435 Tulpe Lo St
Rear of
House

435 Tuepelo St

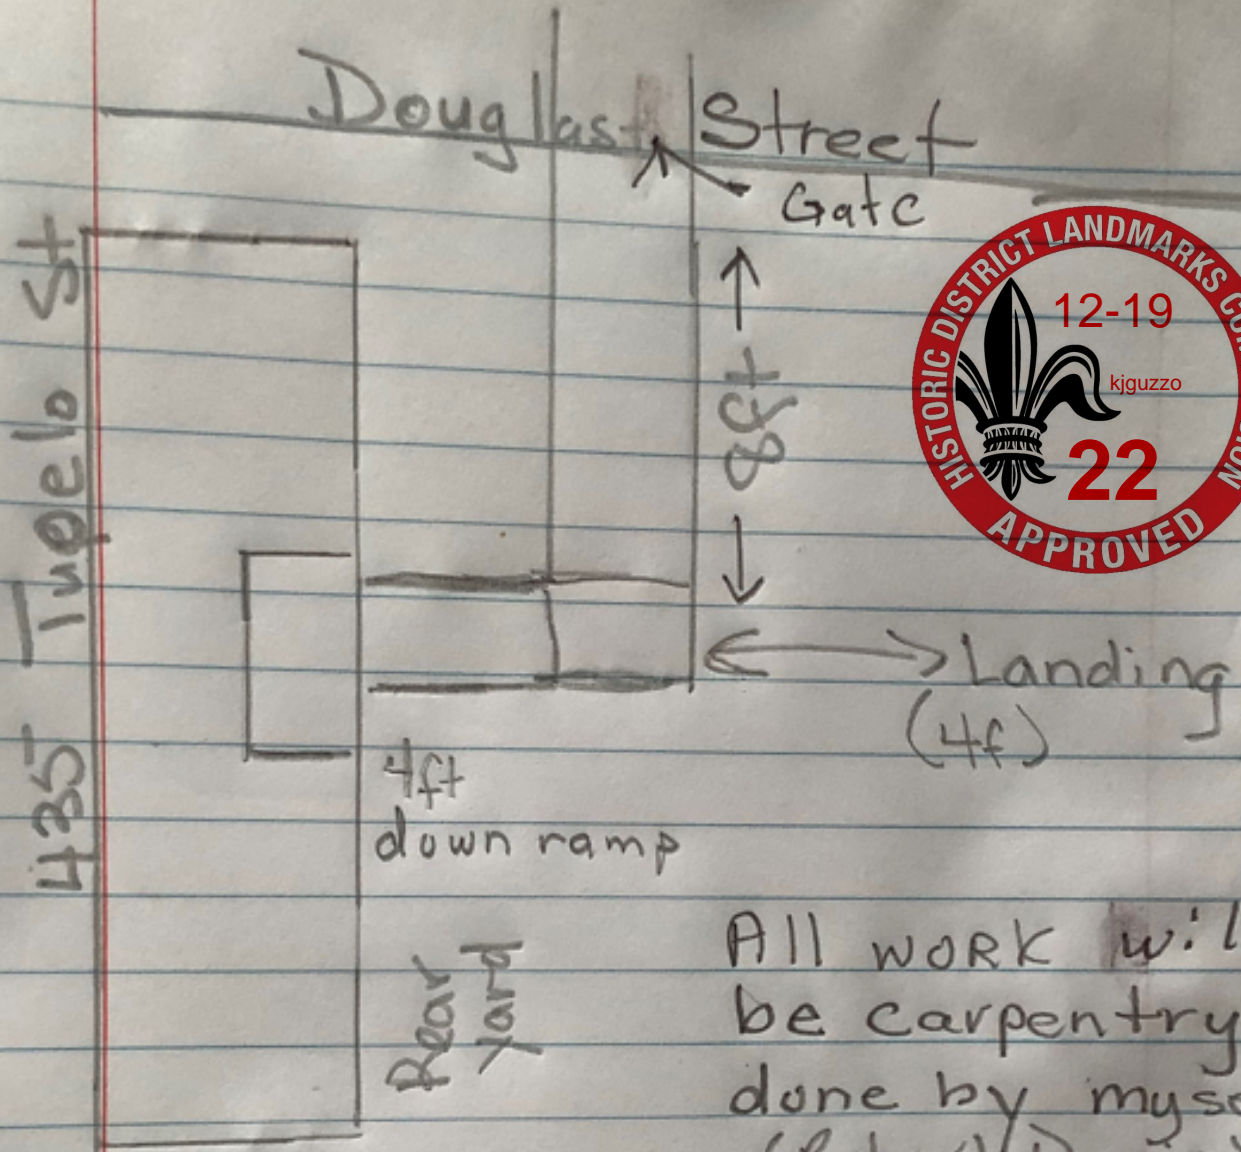
All changes and additional exterior work must be approved by the HDLC

As per applicant email. ramp to be carpentry, constructed of pressure treated wood, anchored to concrete with metal plates. No additional fixtures or elements to be added without HDLC approval.

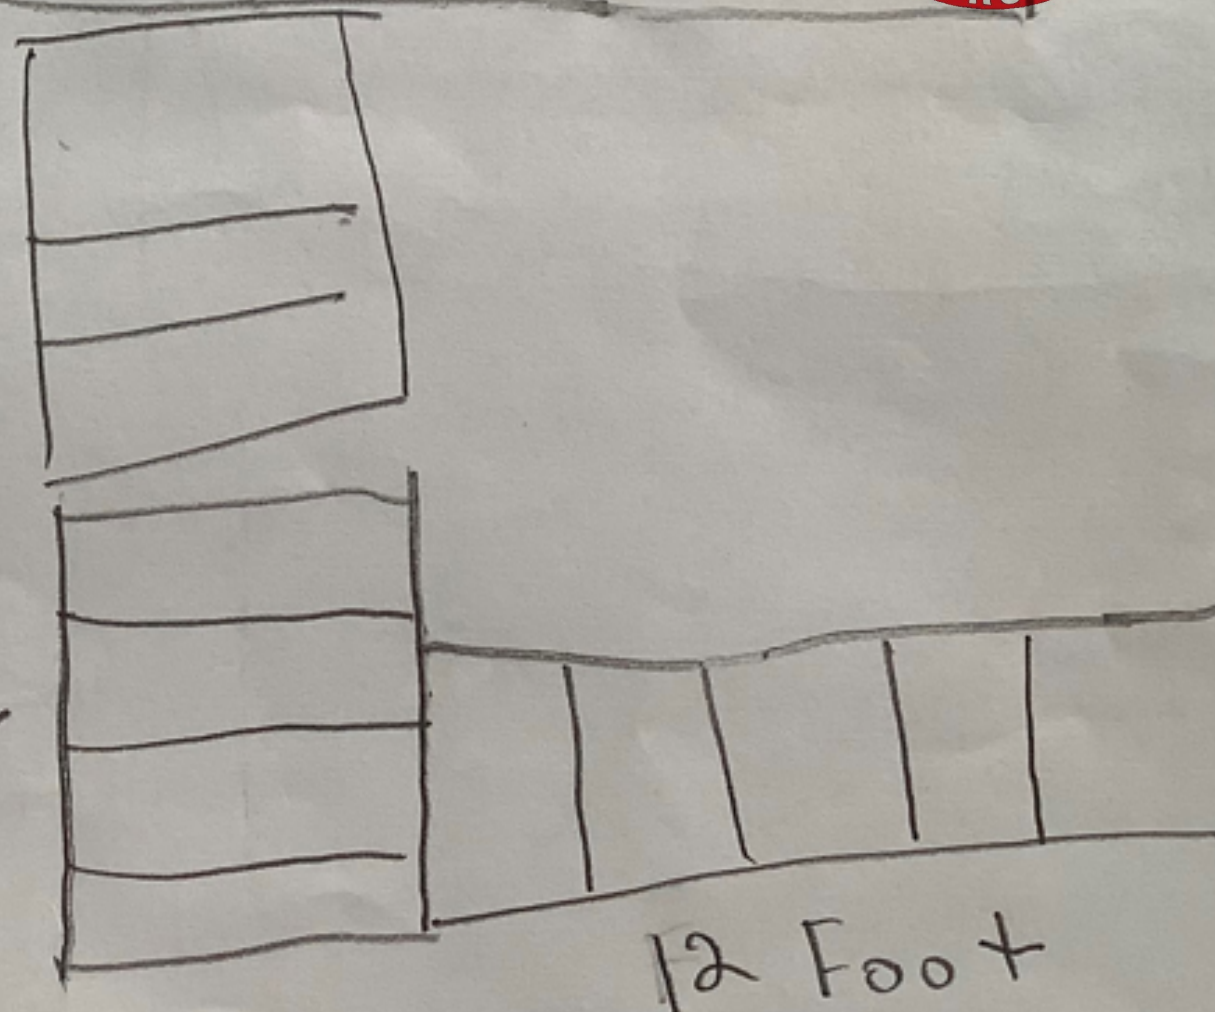
All changes and additional exterior work must be approved by the HDLC

As per applicant email. ramp to be carpentry, constructed of pressure treated wood, anchored to concrete with metal plates. No additional fixtures or elements to be added without HDLC approval.

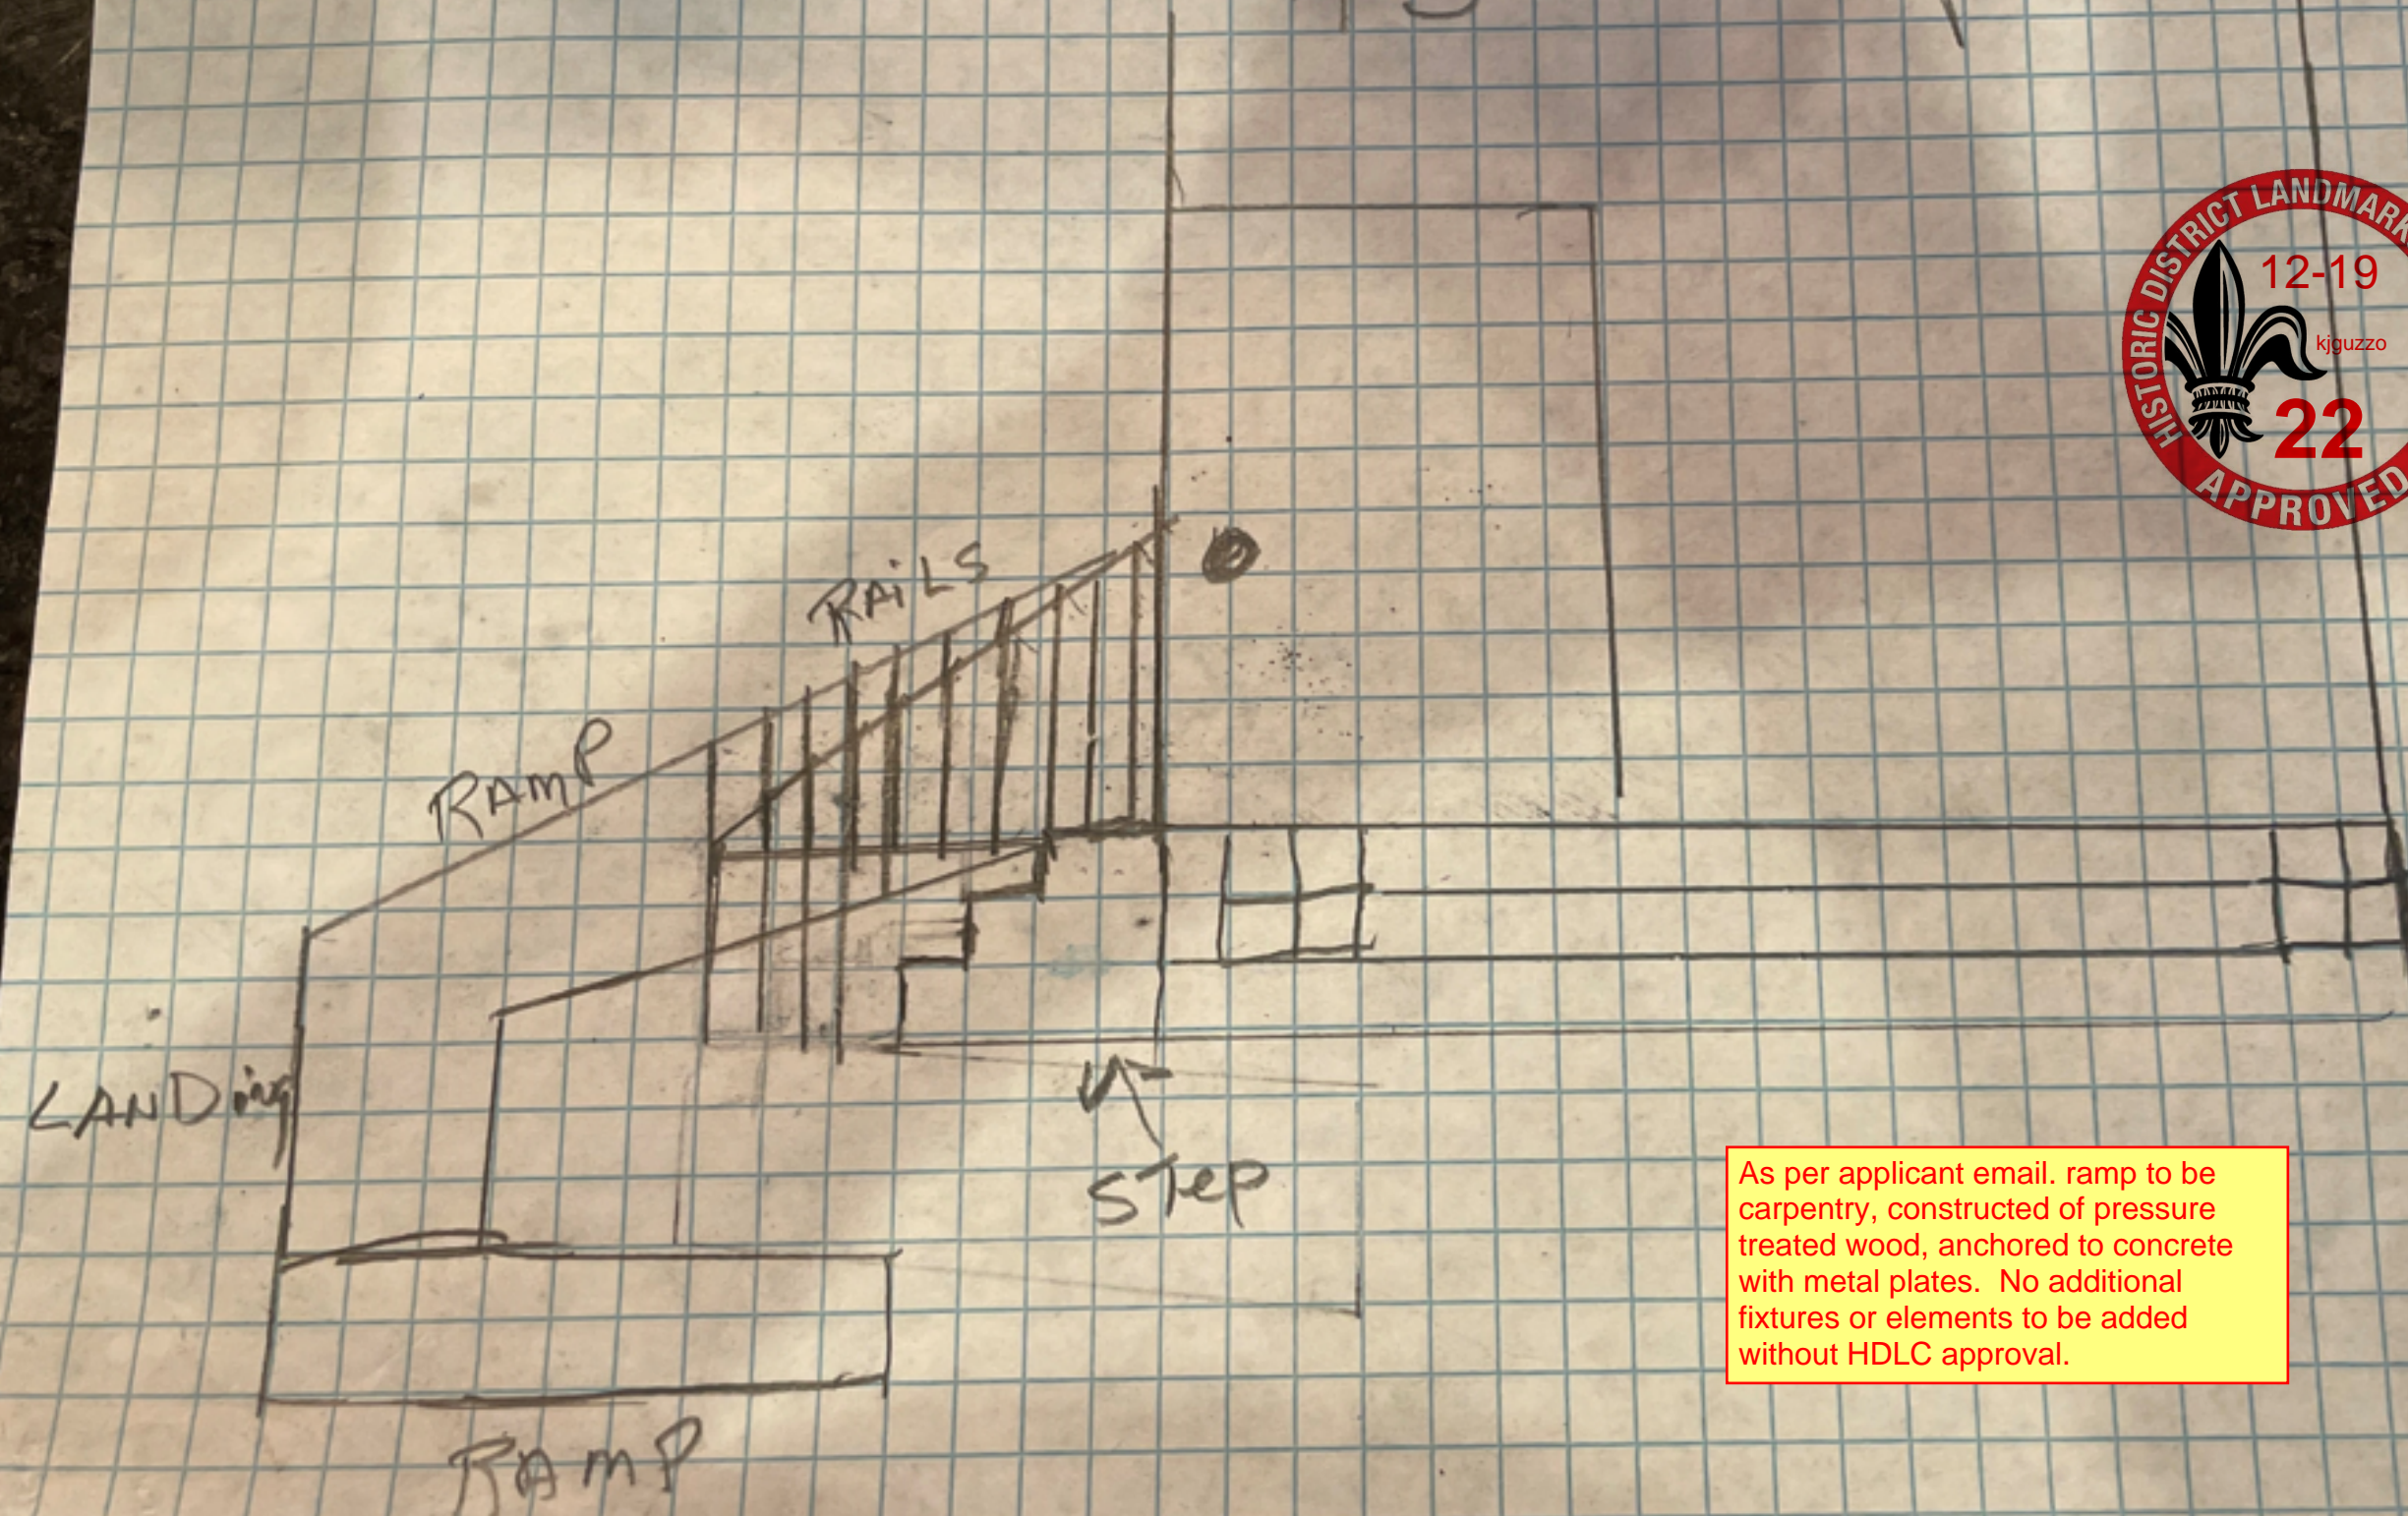
All changes and additional exterior work must be approved by the HDLC

As per applicant email. ramp to be carpentry, constructed of pressure treated wood, anchored to concrete with metal plates. No additional fixtures or elements to be added without HDLC approval.
